SUBJECT: Greater Kankakee Airport
Kankakee, Illinois
Kankakee County
Illinois Project Number: IKK-5242
SBGP Project Number: 3-17-SBGP-TBD
Contract No. KA056
Item No. 05A, June 12, 2026 Letting
Addendum A

NOTICE TO PROSPECTIVE BIDDERS

Reason for Addendum:
Response to Contractor Questions.

GREATER KANKAKEE AIRPORT
REHABILITATE TAXIWAY A -
PHASE 2
813 A EAST 4000 S ROAD
KANKAKEE, IL 60901

5 FULL DEPTH REMOVE & REPLACE BITUMINOUS PAVEMENT - TYPE B (AR401916)

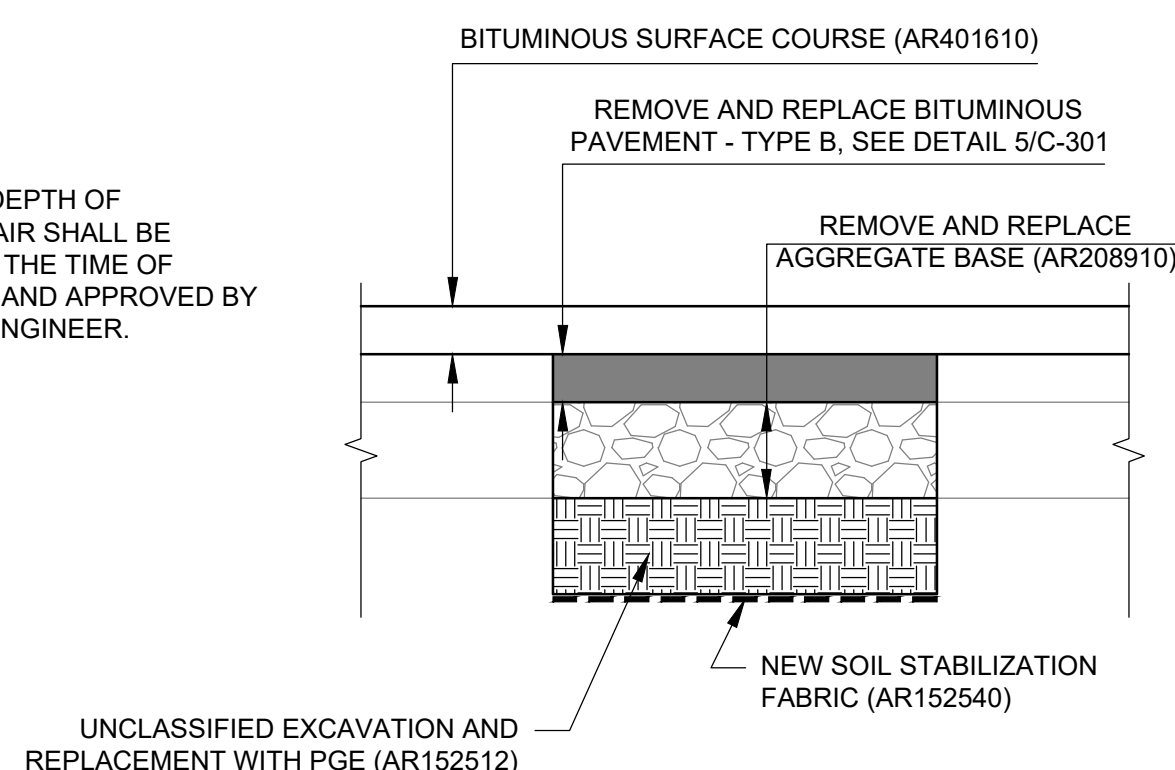
Pages 19 and 20 of the special provisions indicate that Surface Course is supposed to be used for the Remove Replace Bituminous Pavement Type A and Type B; however, page 31 of the special provisions indicates that Base Course shall be used for them. Which is correct.

101-3.18 (Page 20)

The second sentence of the second paragraph shall be replaced with “The replacement of bituminous pavement shall be in accordance with Item 403 Asphalt Mix Pavement ~~Surface~~ **Base** Course.”

The replacement of bituminous pavement for Remove and Replace Bituminous Pavement Type A and Type B shall be in accordance with Item 403 Asphalt Mix Pavement Base Course. Payment for Rem & Rep Bit Pavement – Type A shall be made under AR401915. Payment for Rem & Rep Bit Pavement – Type B shall be made under AR401916.
